Alpine Street
Garage

11-15 ALPINE STREET
SOMERVILLE, MA

REVISION TO ZBA 2016-75
September 30, 2021

List of Changes; Refer to Accompanying Narrative.

Third Floor Plan

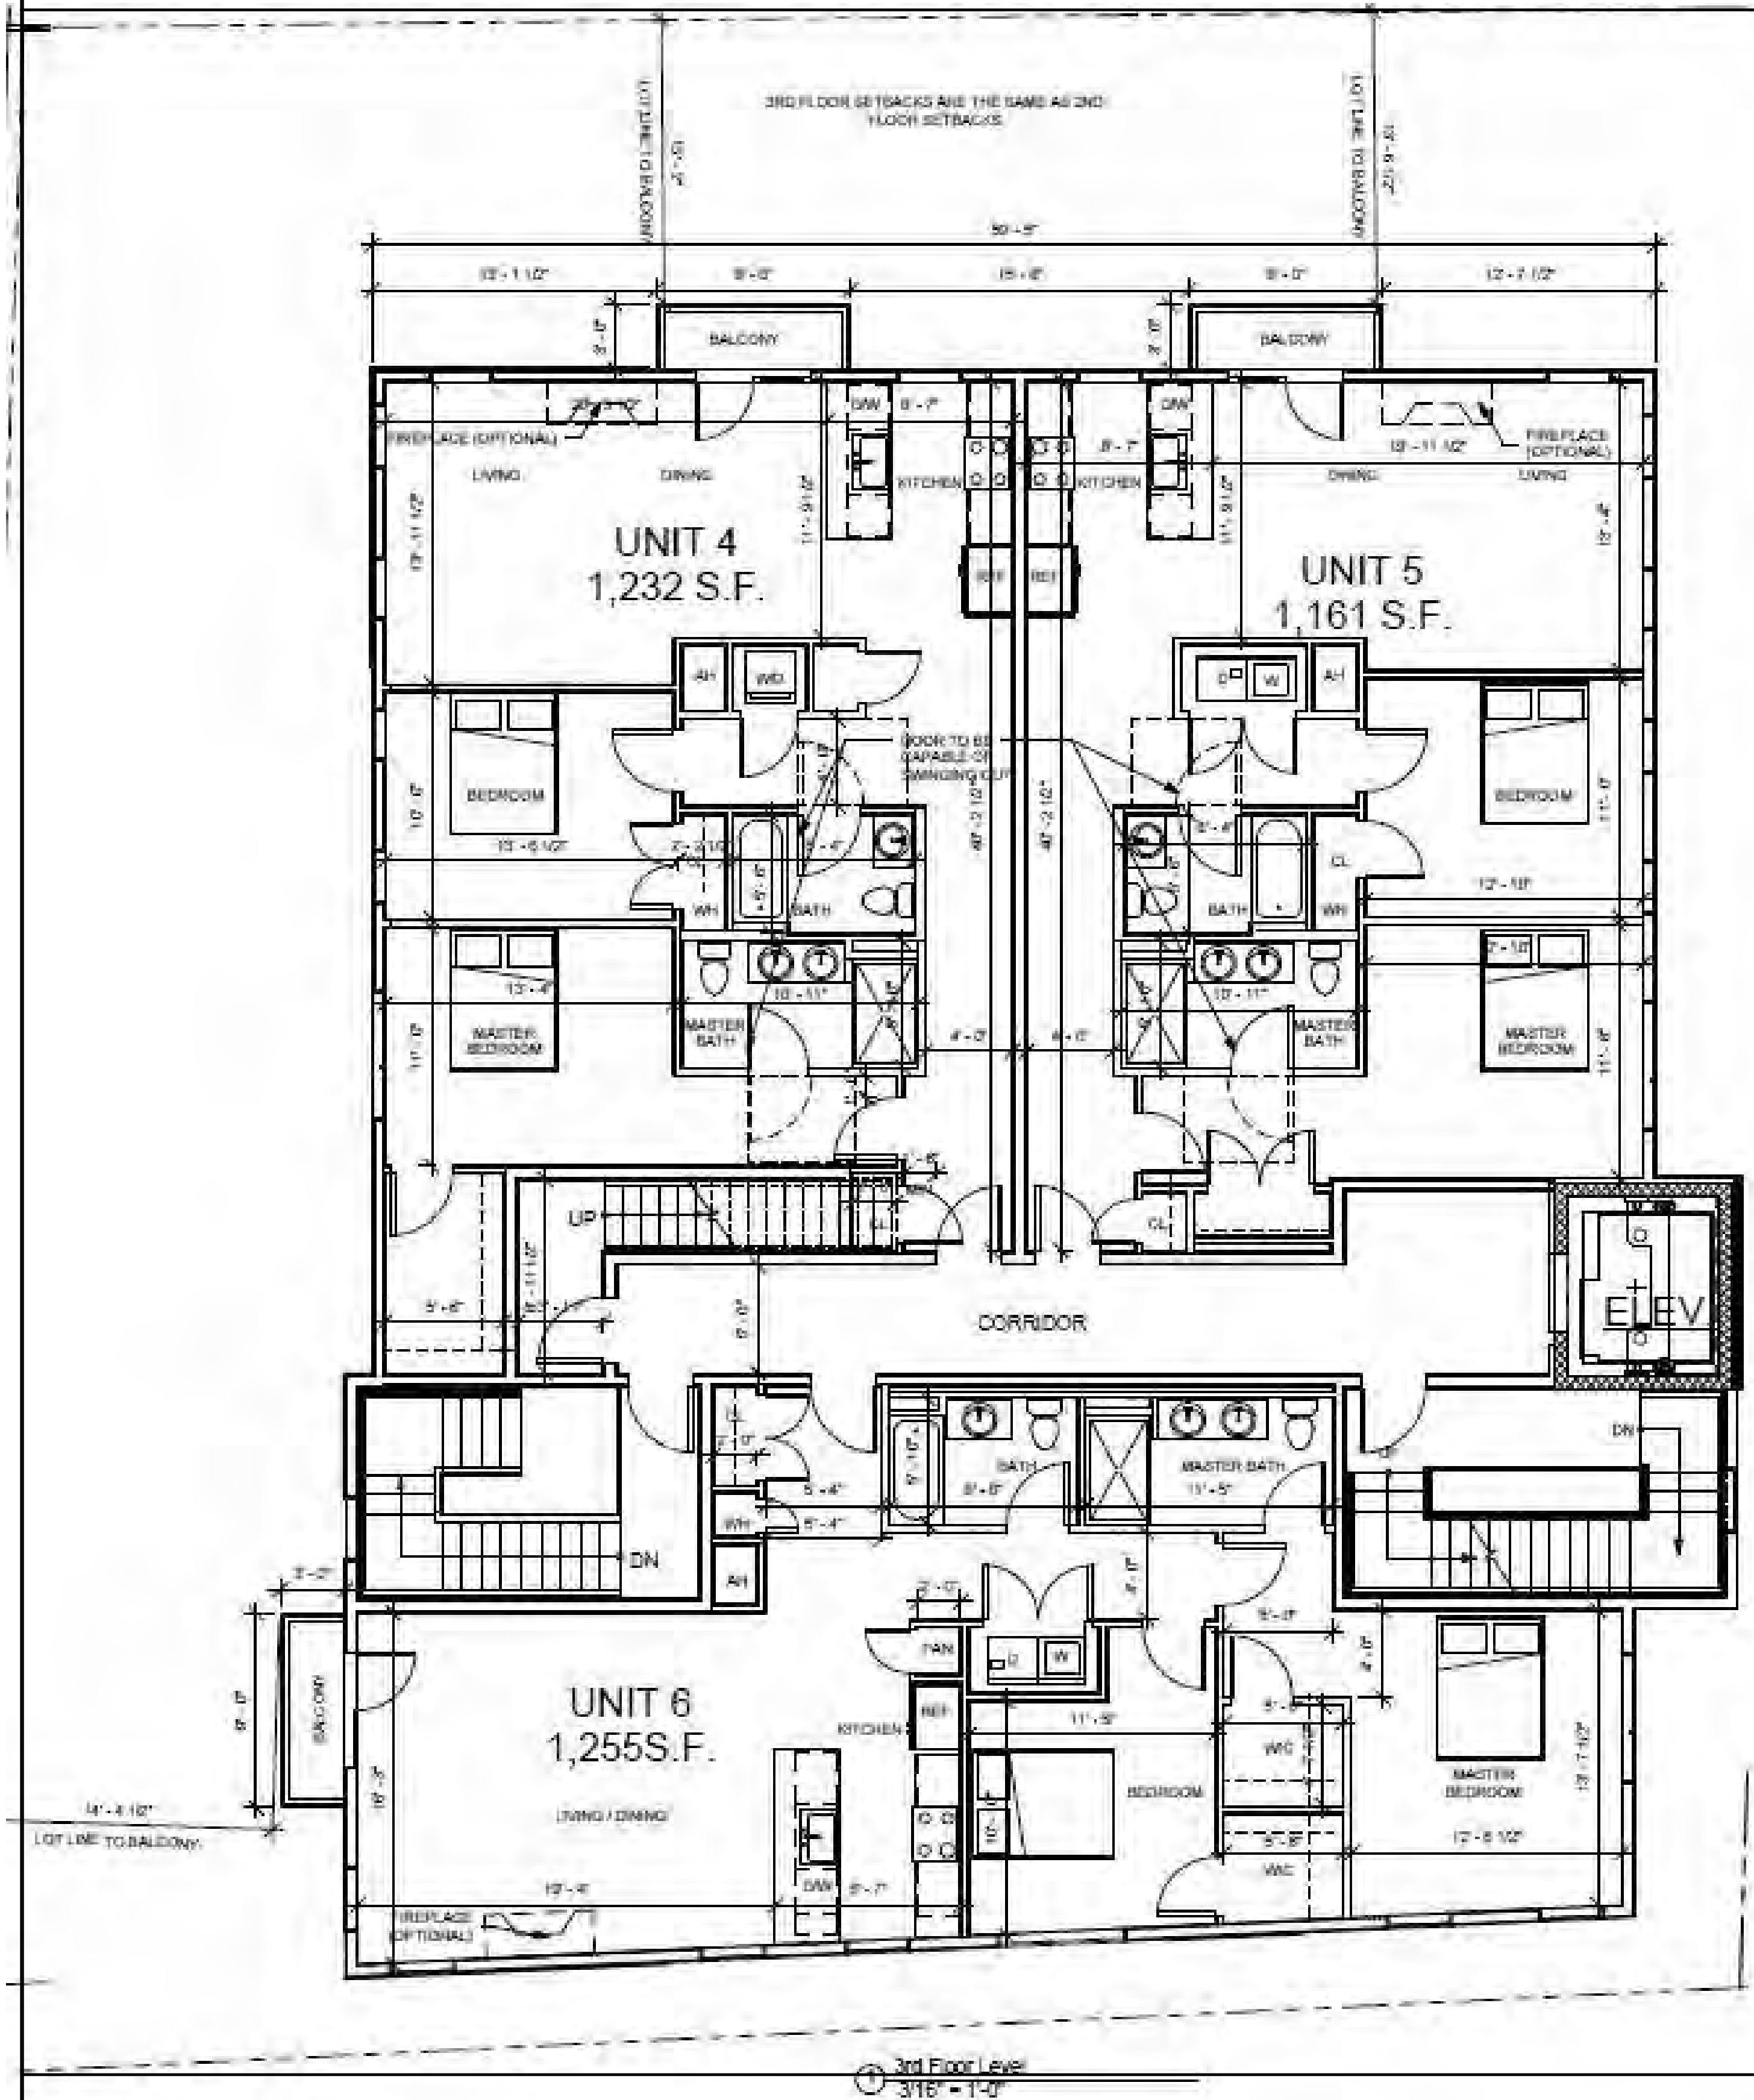
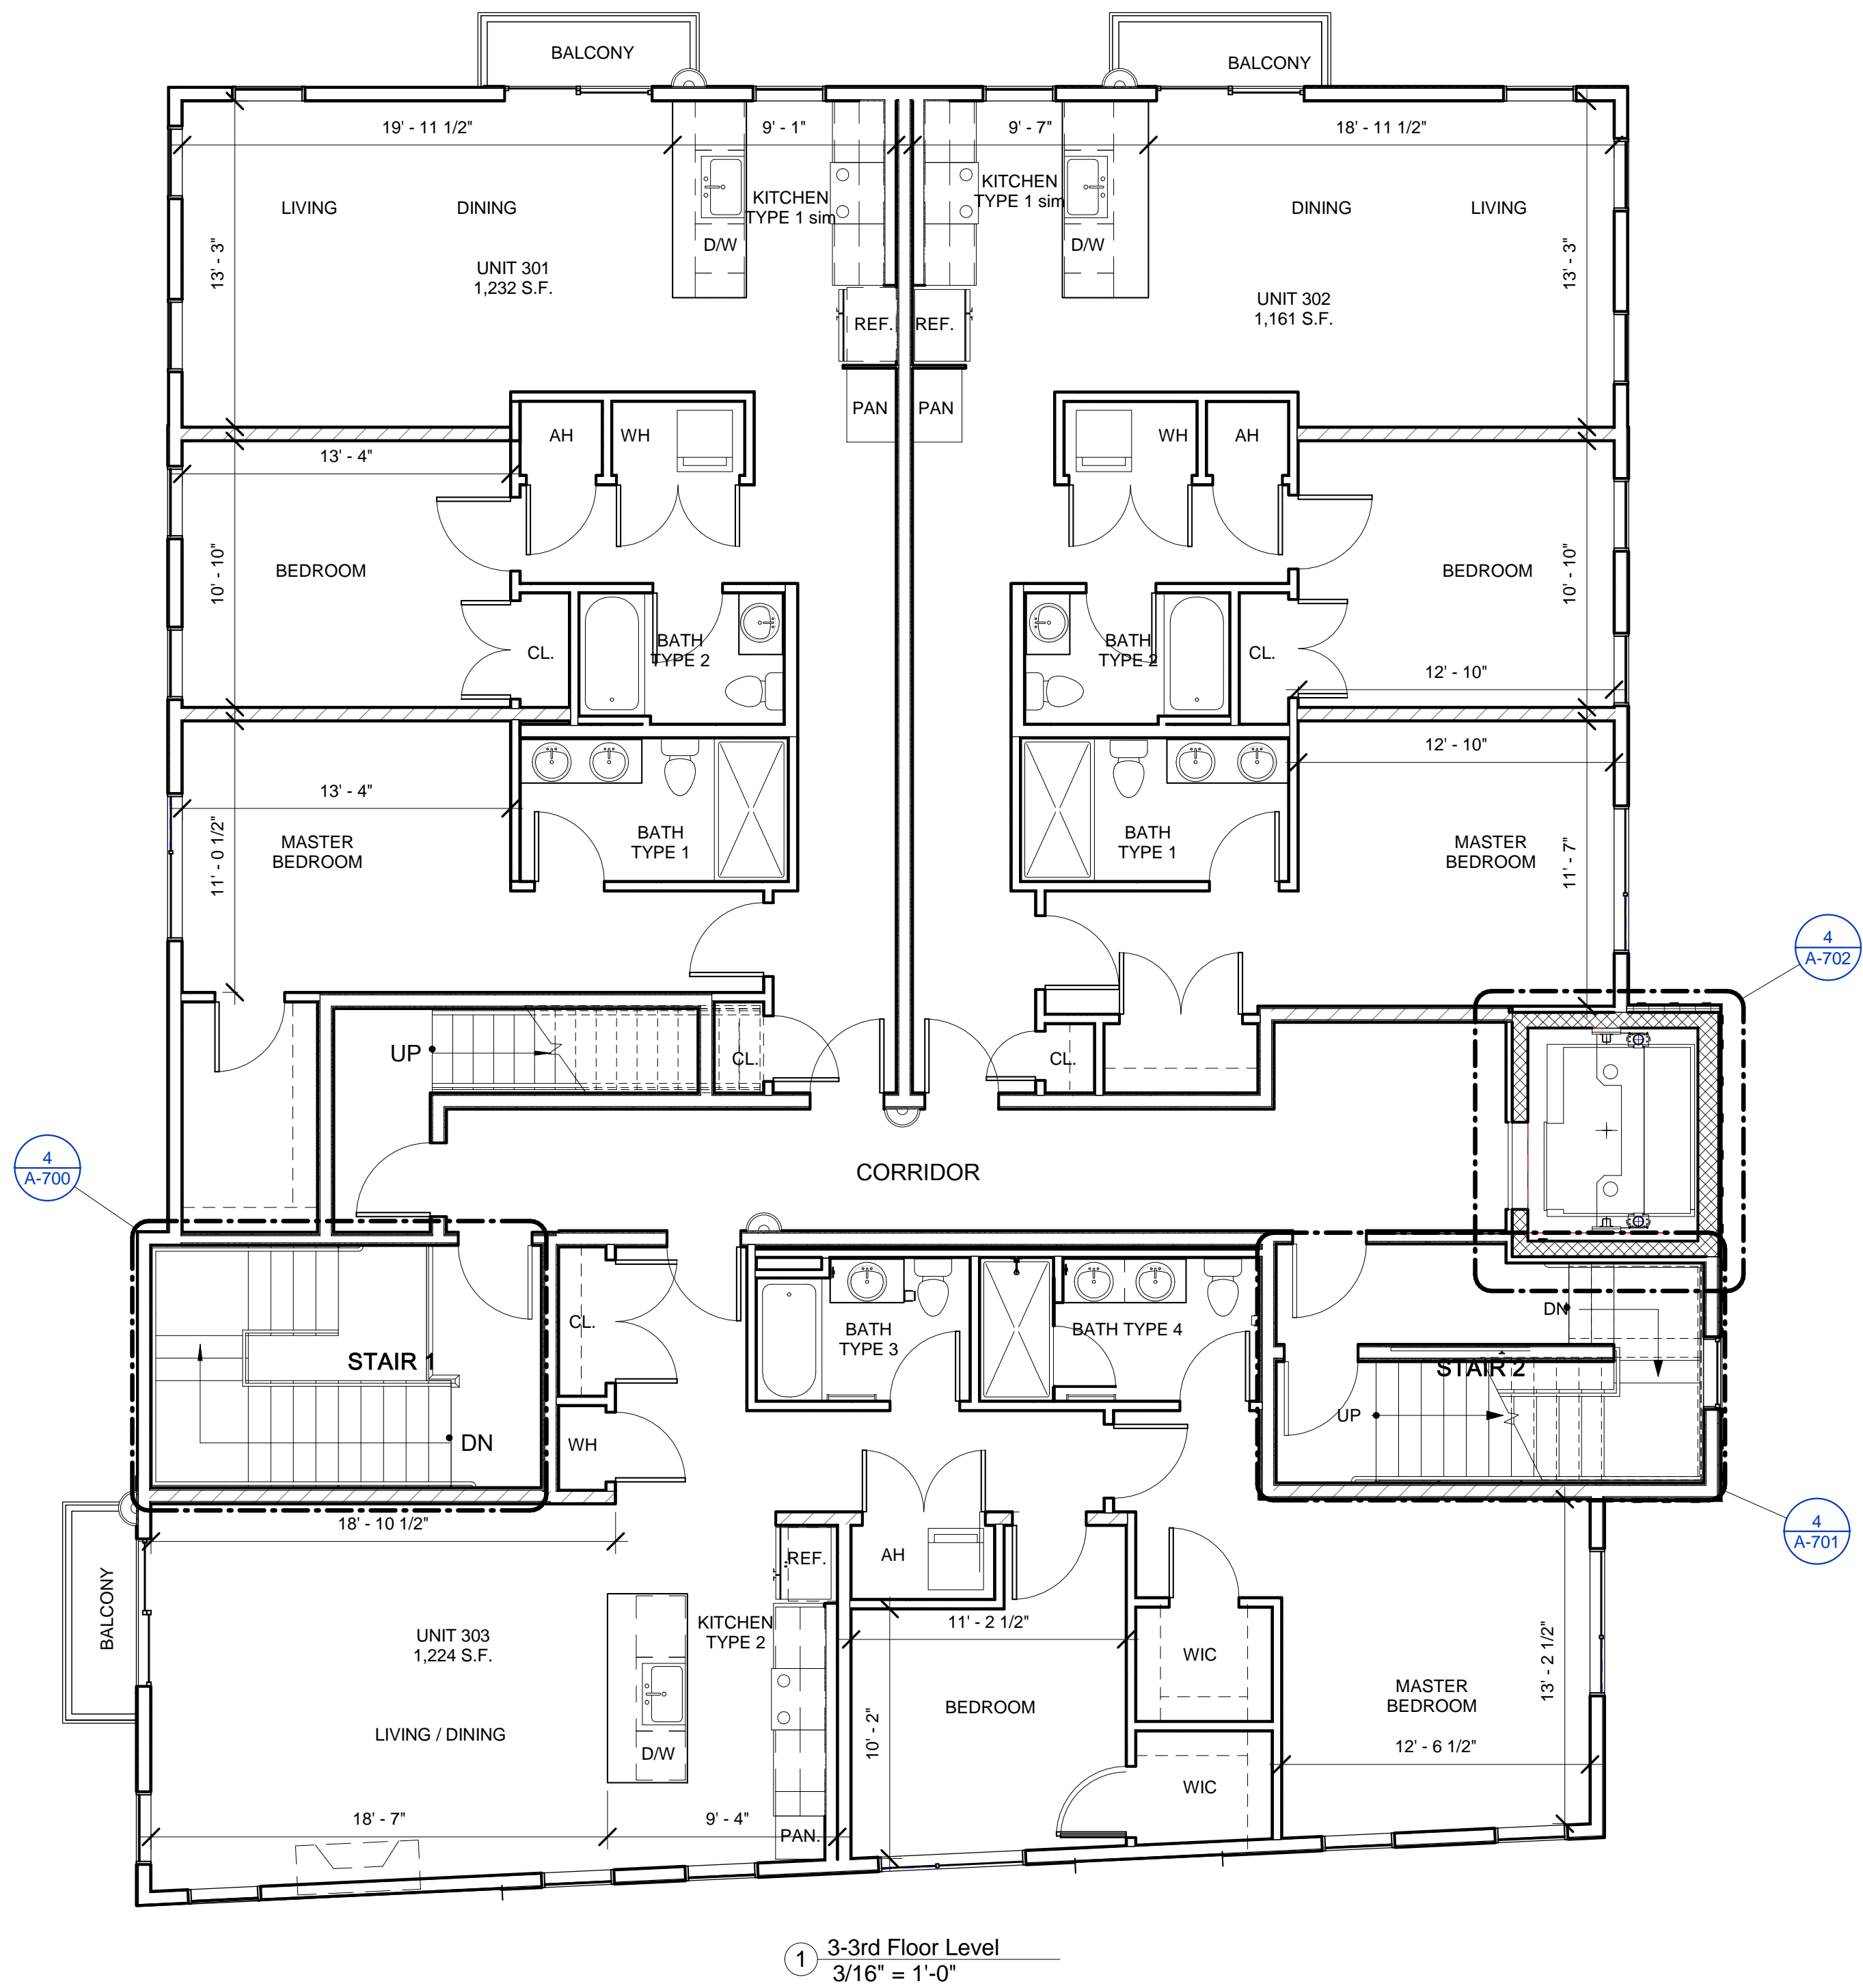
- The right-side elevation staircase overrun on the roof, which is adjacent to the rooftop elevator overrun, has been extended to match the height of said adjacent elevator overrun.

- The batten pattern at the top floor and right-side stair tower has been adjusted.
- New cast stone signage at the center of the front façade is now proposed to read "13 Alpine Street".

- The veneer at the front wall headers and columns is to be changed to cast stone (Arriscraft or Similar).
- CMU block is to be used on the Easterly wall.

- The door and window pattern at the front left side ground floor space has been altered as shown in the elevations.
- The windows have been slightly altered on all facades as shown in the elevations.

- The front wall has been replaced as shown in the elevations.
- The iron railings are to be horizontal.
- Cedar screening of the rooftop mechanicals with safety tie-offs are being proposed as shown.

- The wood decking is being extended to three sides of Unit 401 on the 3rd floor roof (a/k/a the fourth floor deck), thereby creating a larger balcony. The railing is set back 4'-6" from the wall below and planters are being added around the perimeter of the railing.

- Cast concrete planters at the front of the building on the ground floor are being proposed.
- The size and spacing of the planters have been altered on all facades as shown.

- The second floor deck at Unit 201 has been reduced in size.
- The rooftop HVAC units have been located on the roof, near the roof edge.
